AHU-01 Configuration - 60% FD

TITLE: AHU CONFIGURATION OPTIONS  
DATE: 12/12/18  
DRAWN BY: DC

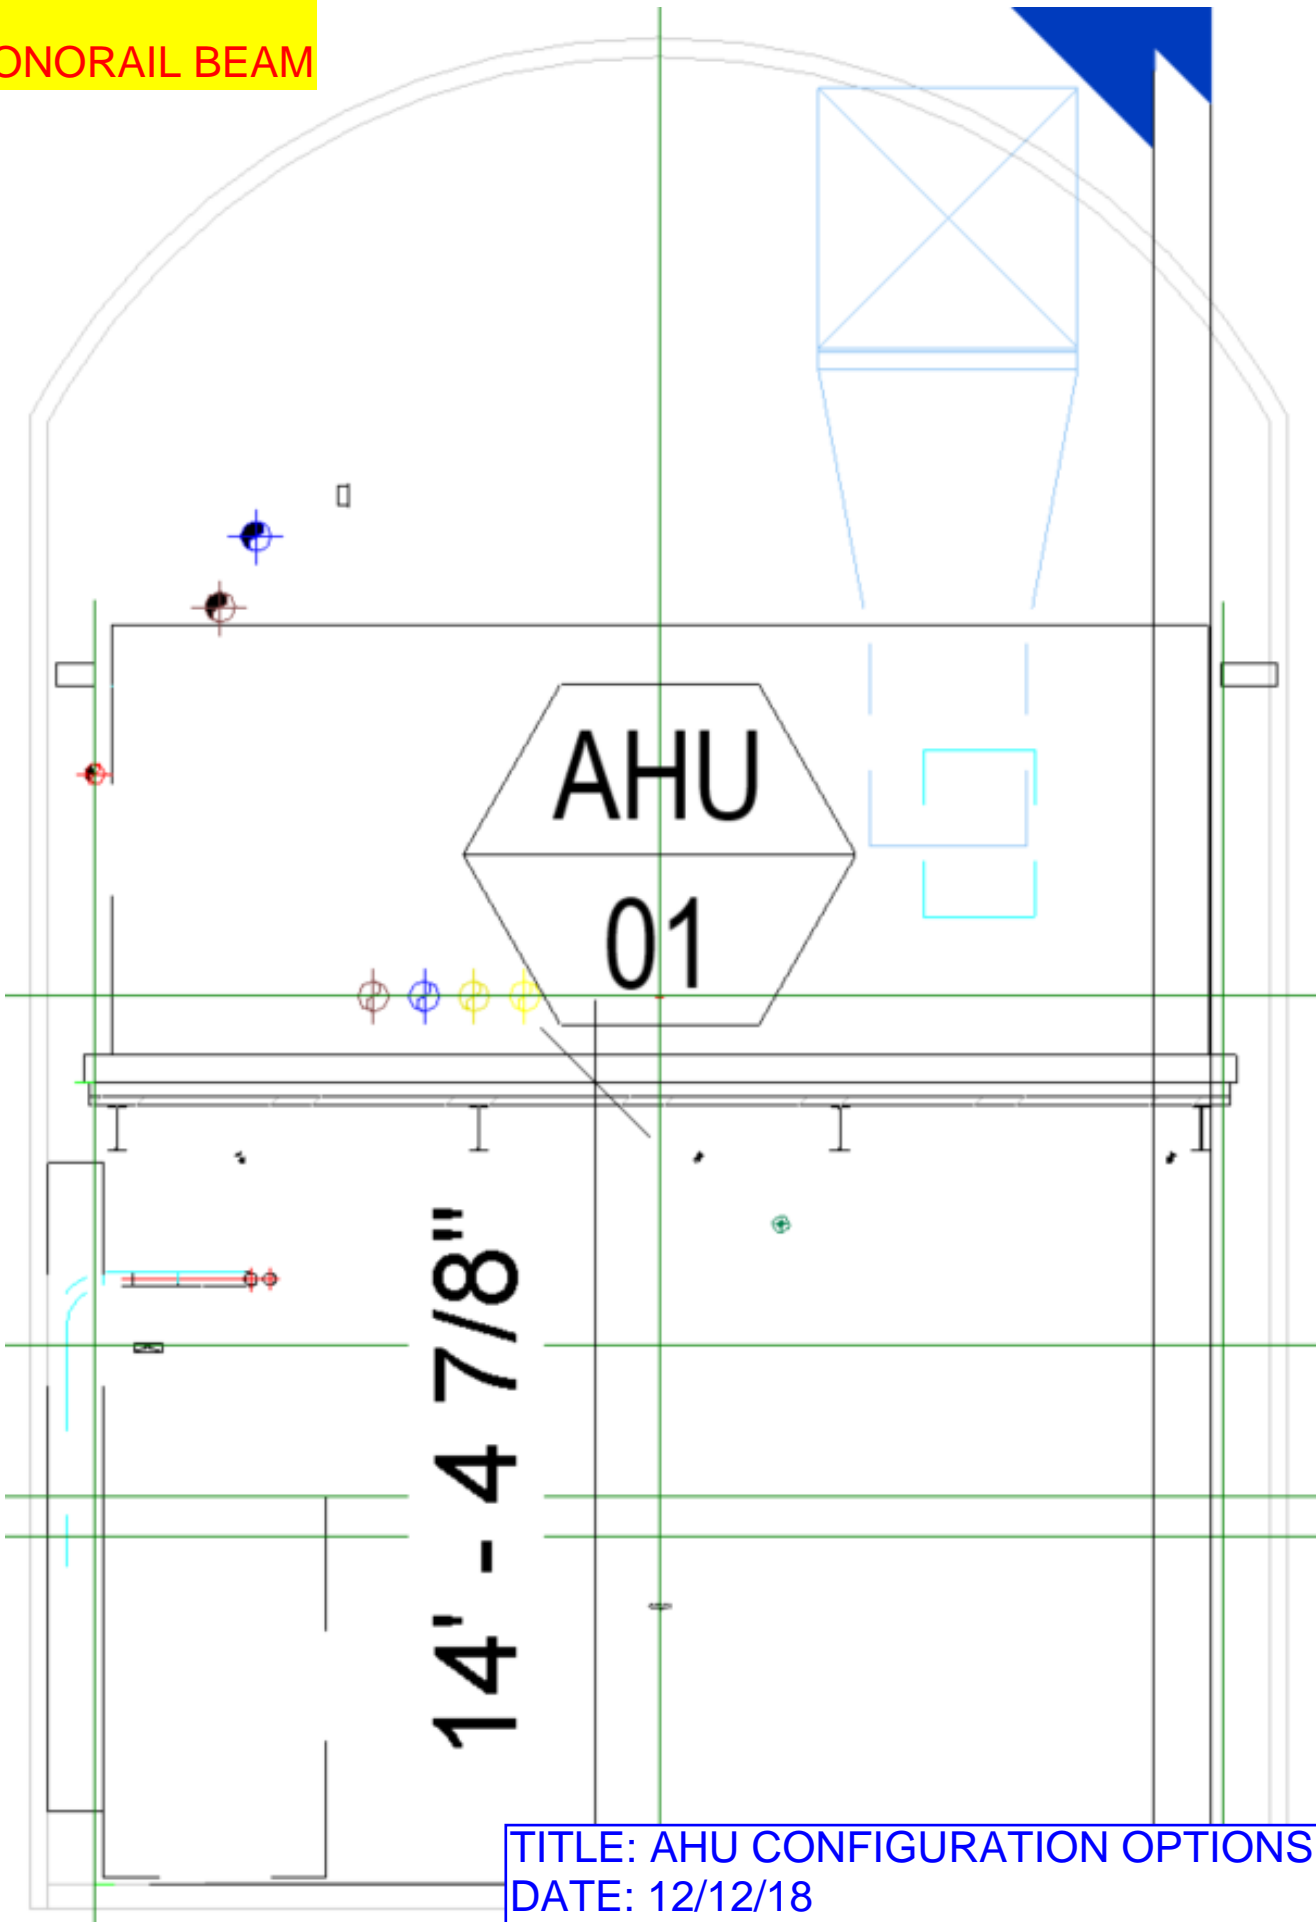
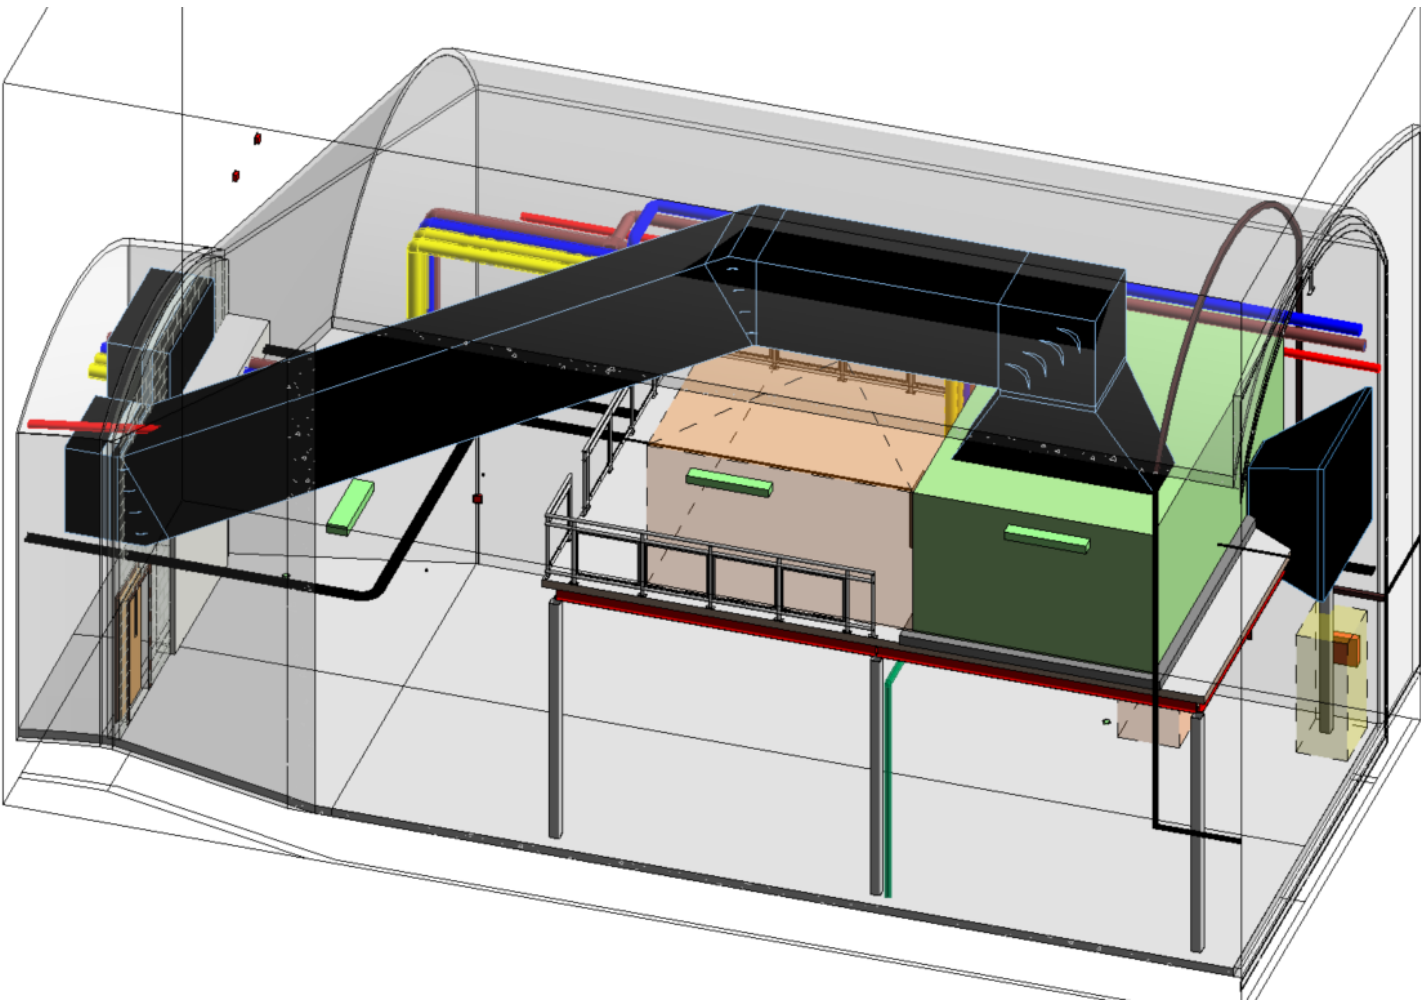
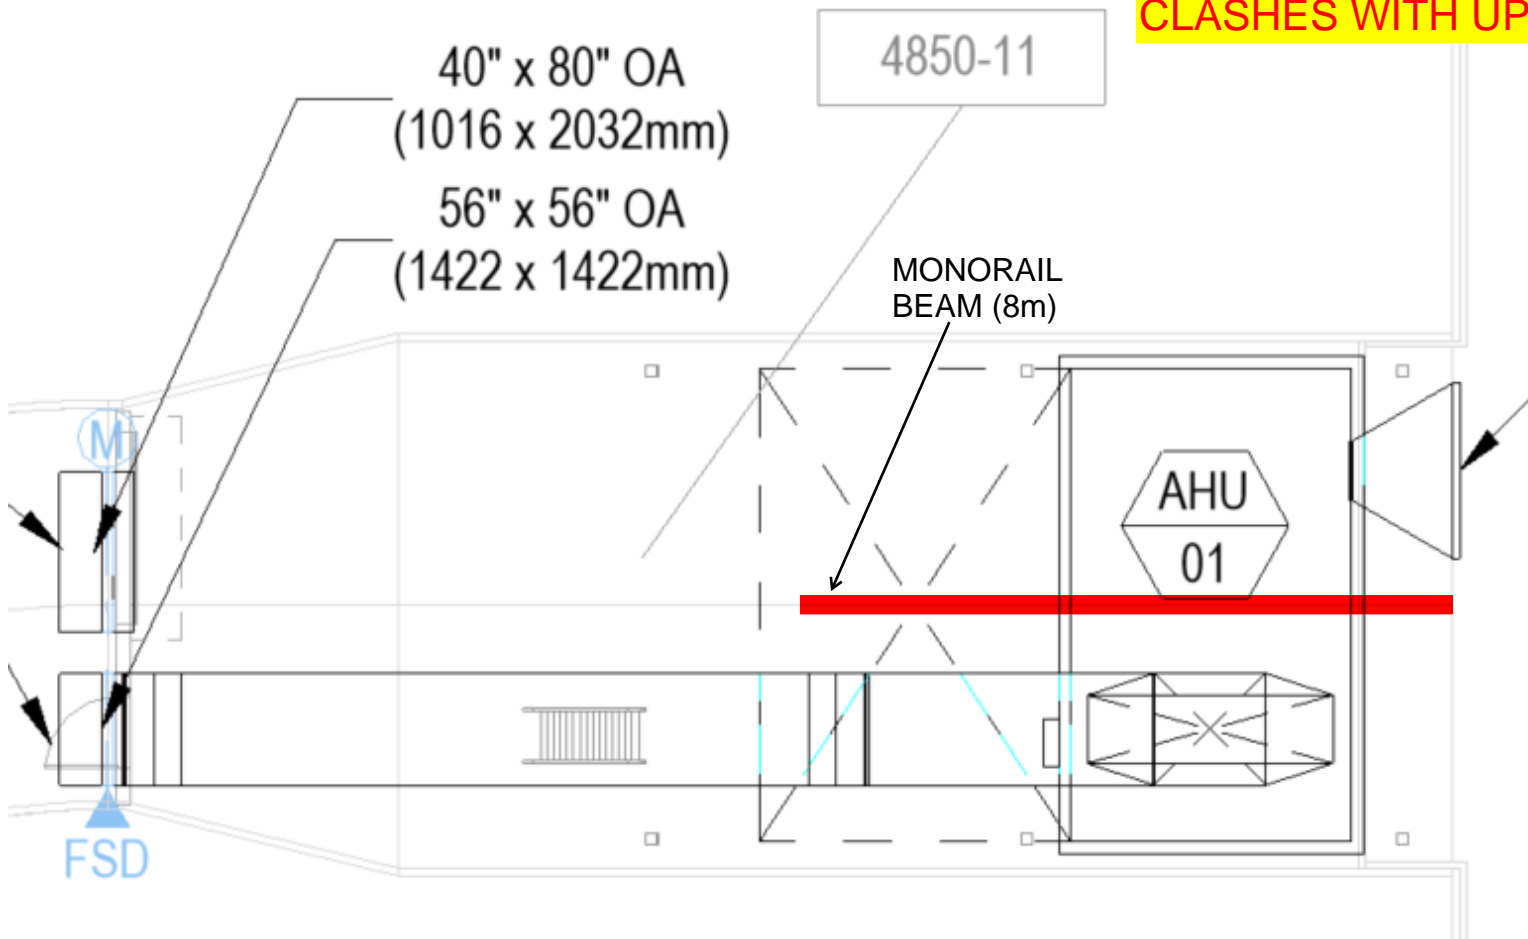
CURRENT CONFIGURATION  
CLASHES WITH UPDATED MONORAIL BEAM

AHU-01 Configuration - Rotate 90 deg

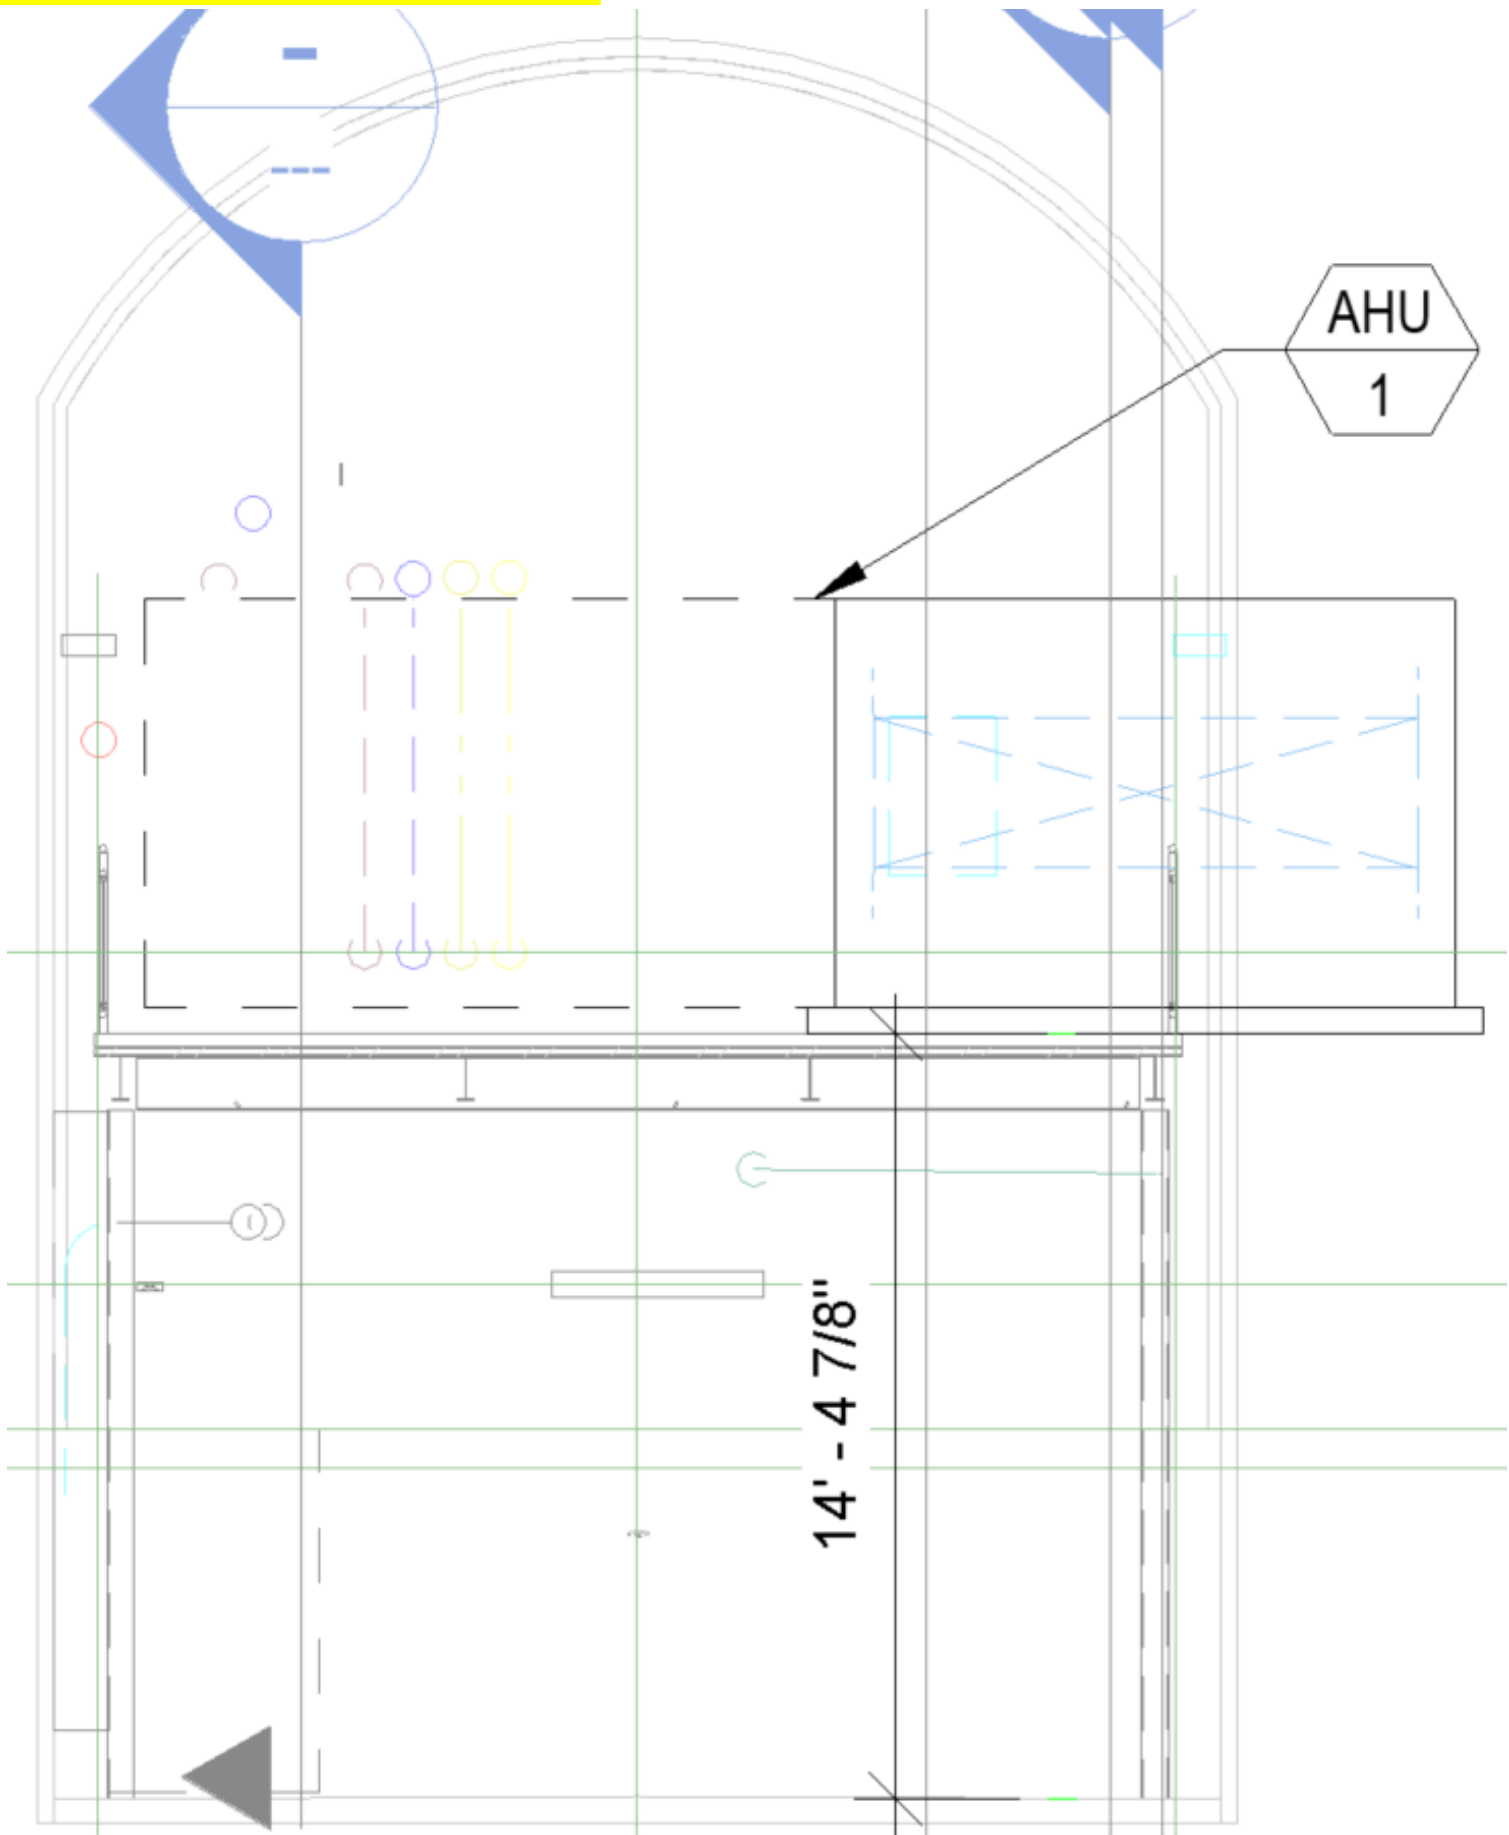
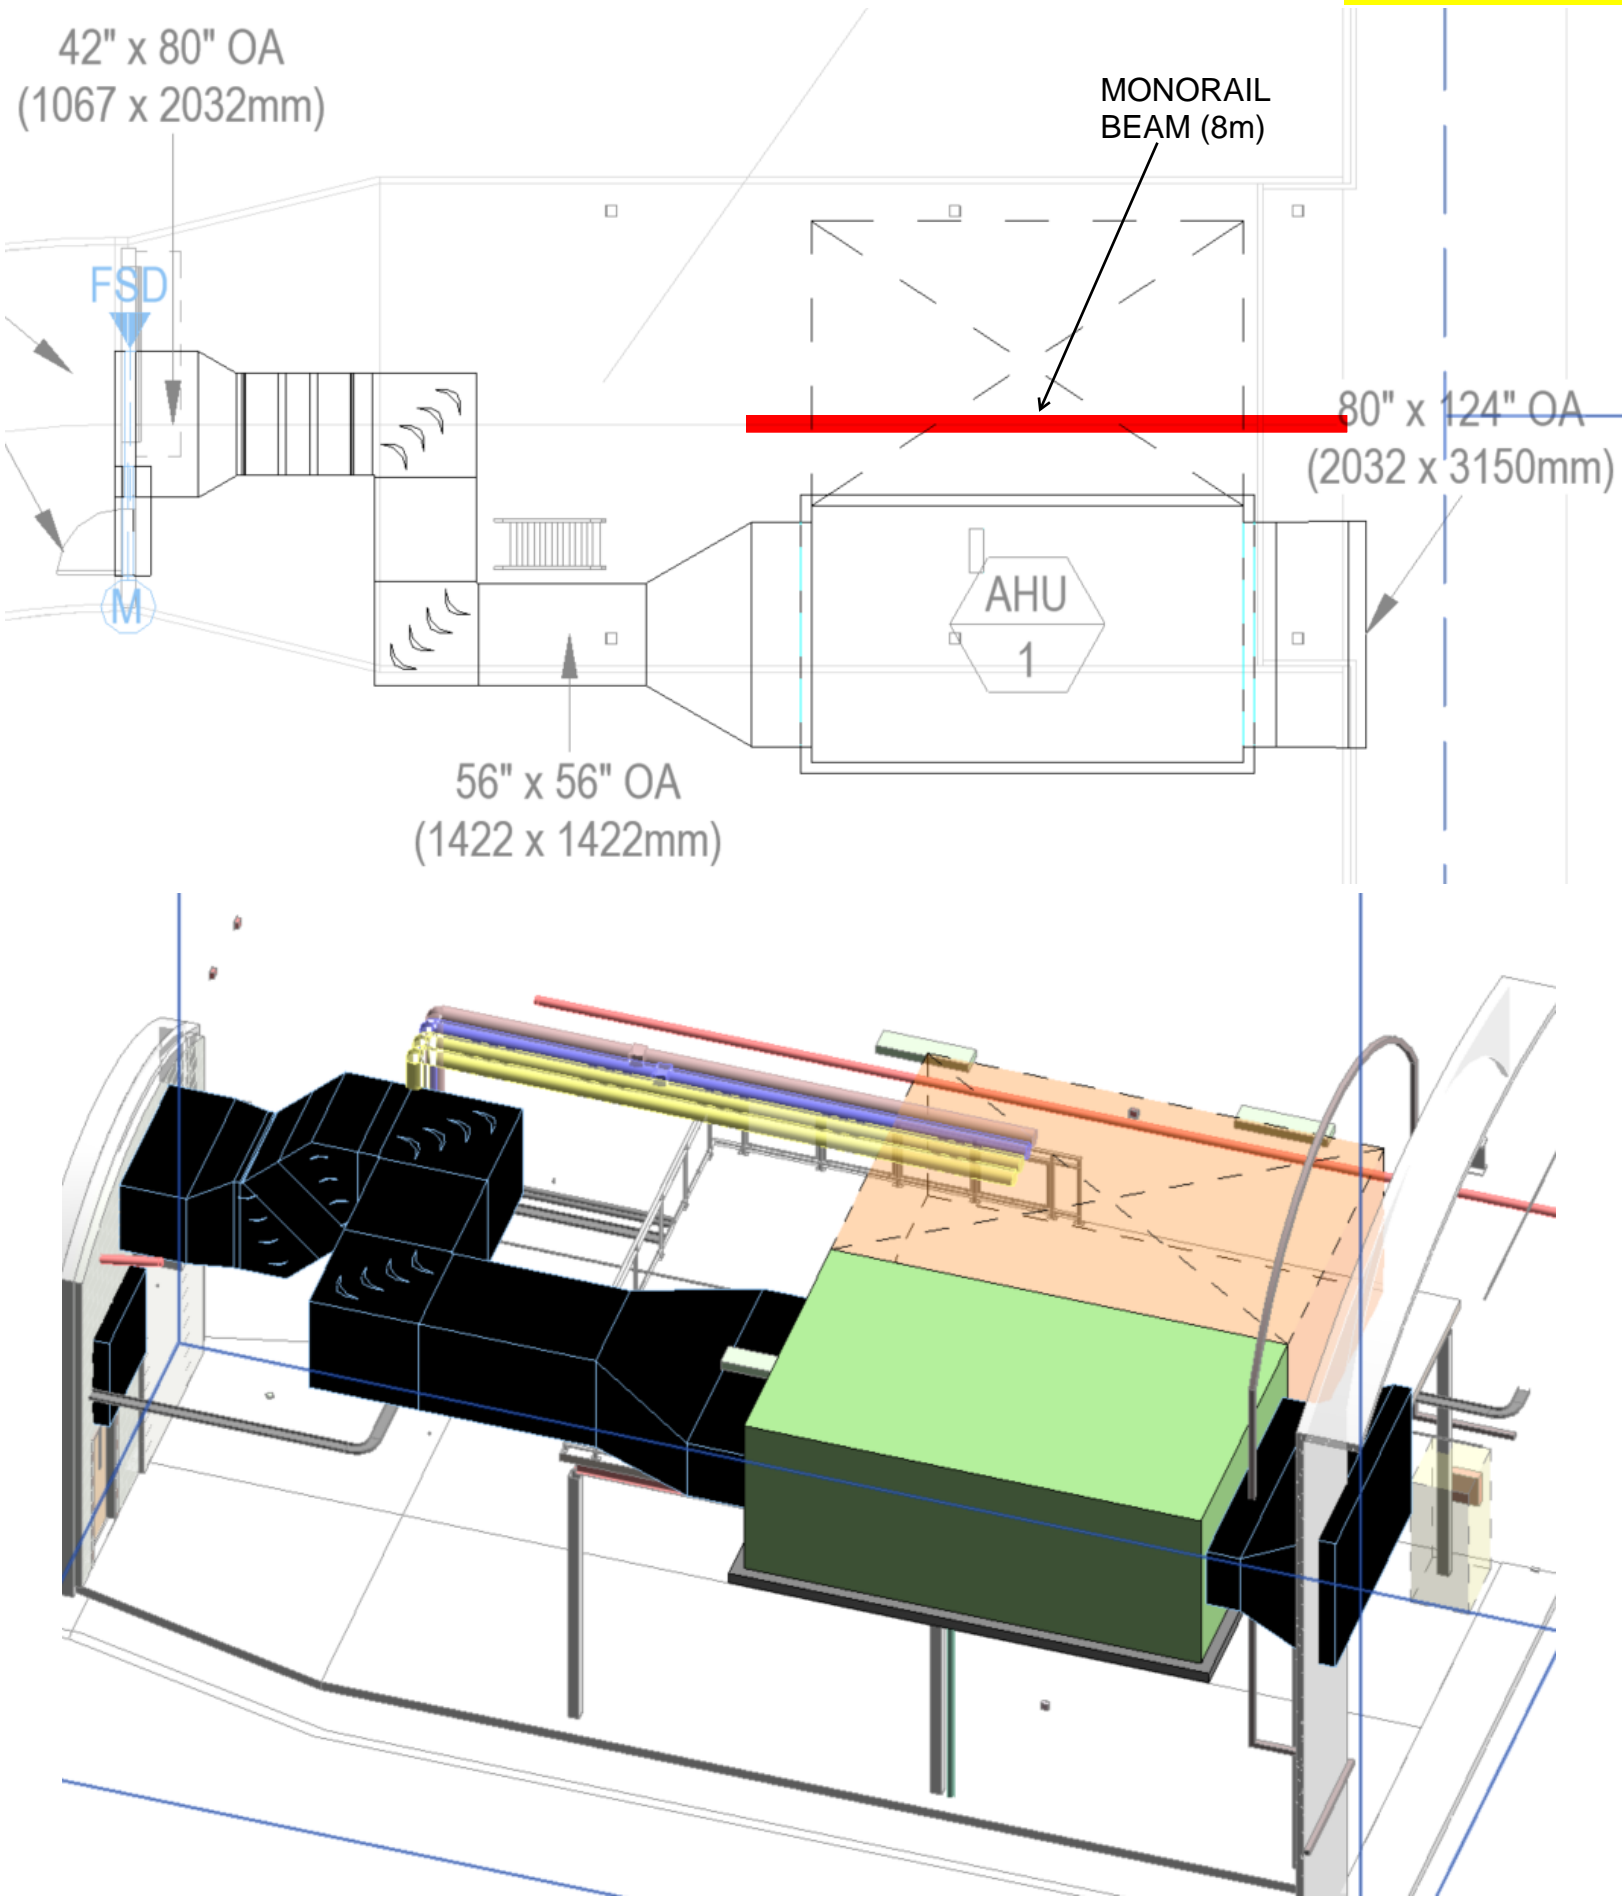
OPTION NOT PREFERRED FROM EXCAVATION PERSPECTIVE
